## ADDENDUM NO. 1

TO: PLANS AND SPECIFICATIONS FOR STATE OF MISSOURI

*Crime Lab-Exterior Renovations Troop-H Headquarters Building  
3525 North Belt Highway, St. Joseph, Missouri 64506  
PROJECT NO. R233801*

SHEET NUMBER:  
C-105  
7 OF 35 SHEETS  
03/28/2014

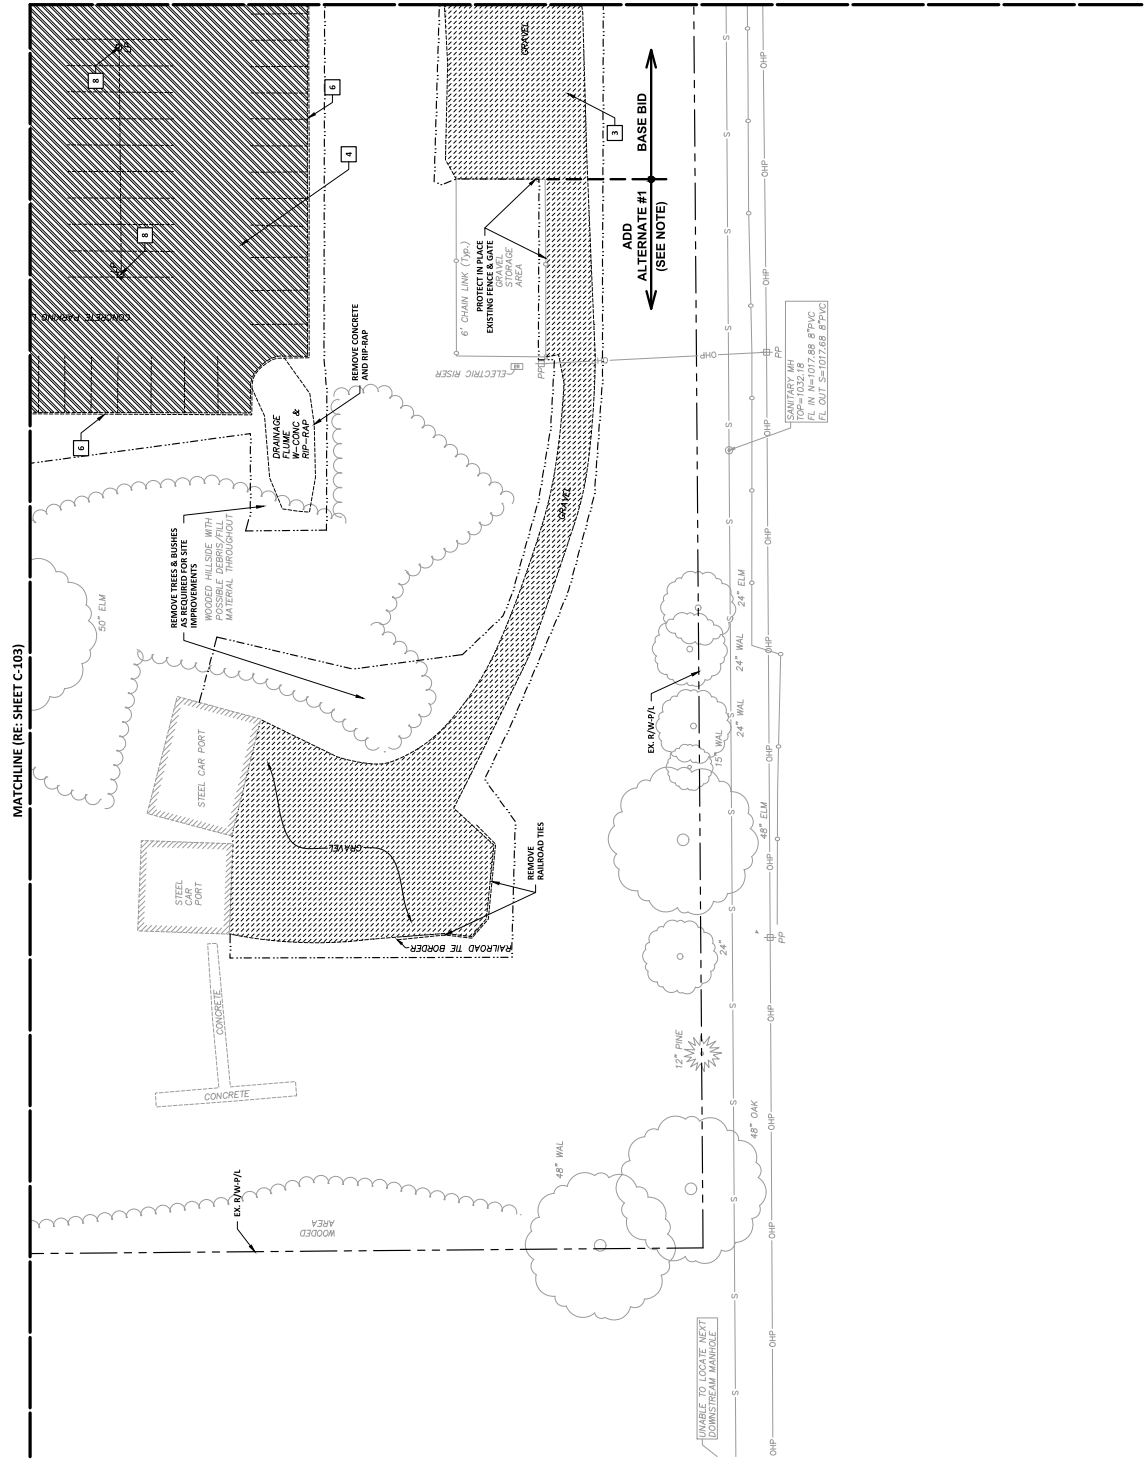
1. Drawing C-105:
  - a. *CLARIFY add alternate #1 note to indicate rip rap and trench drain is included in the base bid.*
2. Drawing C-109:
  - a. *CLARIFY add alternate #1 note to indicate rip rap and trench drain is included in the base bid.*
3. Drawing C-113:
  - a. *CLARIFY add alternate #1 note to indicate rip rap and trench drain is included in the base bid.*
4. Drawing C-117:
  - a. *CLARIFY add alternate #1 note to indicate rip rap and trench drain is included in the base bid.*

**ADD ALTERNATE #1 NOTE:**  
ADD ALTERNATE INCLUDES REMOVAL OF EXISTING GRAVEL AND ASPHALT PAVEMENT AND TRUCK DRUM INCLUDED IN BASE BID.

E-200

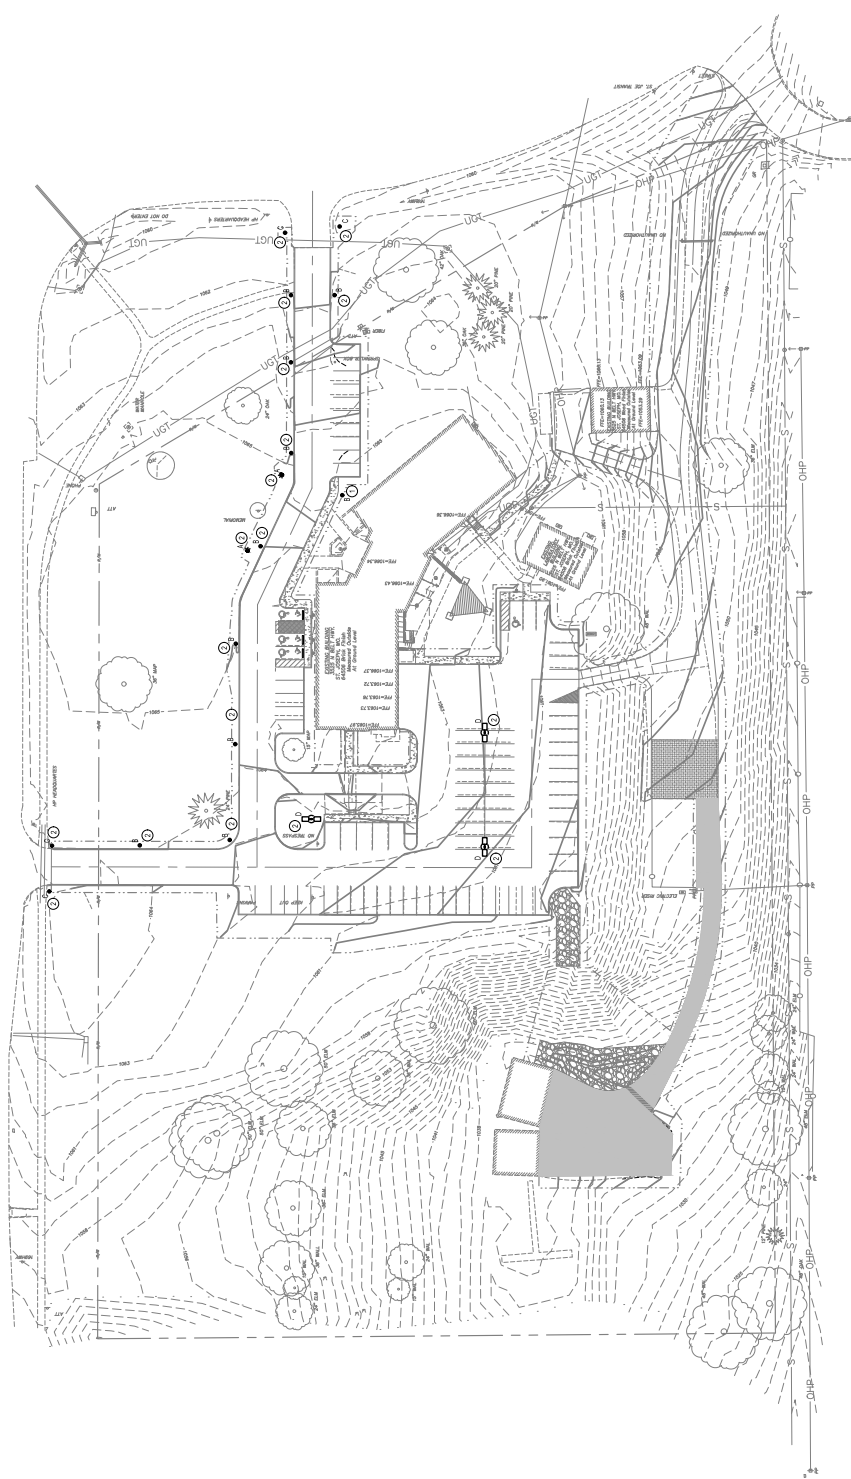
5. Drawing E-200:
  - a. CLARIFY all new parking lot light poles are to have two fixtures with added note.
  - b. REVISE general note #4 to replace all existing electrical conduit and wiring.
6. Drawing E-300:
  - a. ADD item #12 in summary of quantities table for Parking Lot Area Light Poles
7. Drawing E-301:
  - a. ADD "or approved equal" to the light pole specification product information.

1. Are we to reuse the existing underground cable for new electrical installation? I had two of my guys that have serviced this over the years and the existing cable has had many repairs/splices to it and would not be a good situation to move forward with this for the new installation.

2. If you reference Sheet Number E-300; D. NEW- Parking Area Light- the new parking area light shows a single headed light fixture while the final product is to be a double headed fixture, thus arose the question: Would you like the Parking Area Light to have a Fixture on each side of the pole, creating a "double headed" fixture? If so, we will need to order six (6) of the Parking Area Lights.

*Response: All existing electrical conduit and wiring which is broken or not functioning shall be replaced as approved by Engineer and Owner. A unit cost has been added to the Bid Form.*

*Response: That is correct. You will need (6) fixtures for the (3) Poles in the parking lot.*

**E-301**

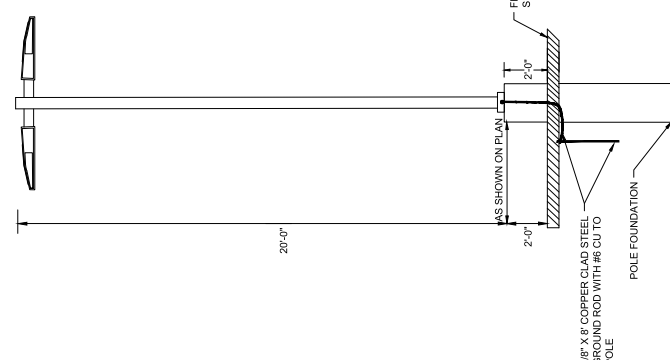
3. If you reference Sheet Number E-301; Pole Specifications: Catalog NO. P200-APR-G-M00-AB- C/W 140(25/40); Will those new Parking Area Light Poles, be provided or need to be purchased by the contractor/subcontractor? The current poles will not support a double headed fixture.

*Response: Yes, they need to be purchased as well and do not come with the Galleon II fixtures.*

CATALOG NO.: P200-APR-G-M00-AB (OR APPROVED EQUAL)
